**WRITTEN STATEMENT: CONDITIONAL USE PERMIT (CUP)
FOR LETURNO-HWY 126**

AGENCY FILE NO.: PC 24 01 CUP 01 (PC 23 27 CUP 04)
AGENCY CONTACT: WENDY FARLEYCAMPBELL, AICP,
COMMUNITY DEVELOPMENT DIRECTOR
CITY OF FLORENCE
WENDY.FARLEYCAMPBELL@CI.FLORENCE.OR.US

DATE OF THIS DOCUMENT: 07/24/2024

APPLICANT FILE NO.: 23-022 LETURNO HWY126
APPLICANT'S REP: JED TRUETT, AICP
METRO PLANNING, INC.
JED@METROPLANNING.COM
TEL (541) 302-9830

Figure 1 - Proposed attached Single Family Tandem Style Home<sup>16</sup>

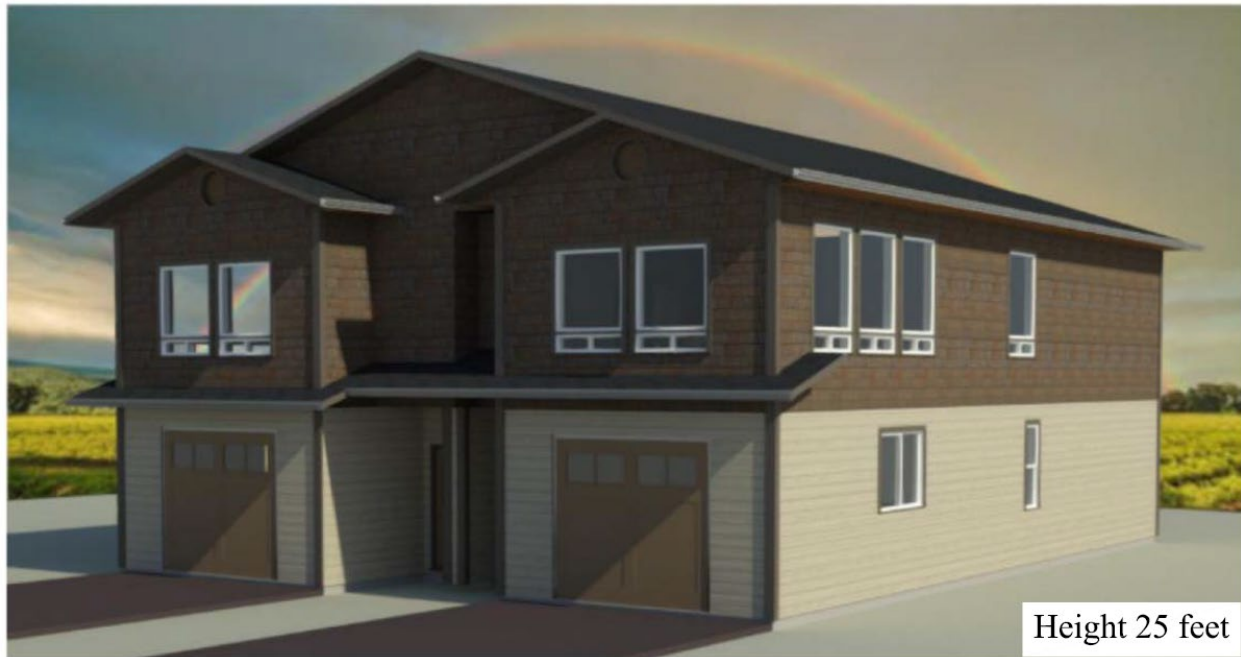
***Provide dimension and additional details for the dwelling entrance that meets criteria of FCC 10-10-7-C-4b. (Staff comment, 10/12/2023 Letter of Completeness)***

Response: the attached detail of the proposed structures now has additional dimensions shown at the entrance. The covered areas are slightly less than that required by the code section above, but that code section applies to residences fronting on a public street. In this case the residences are fronting on an internal private drive and are a distance away from Highway 126, so the applicant is suggesting that this standard does not apply here.
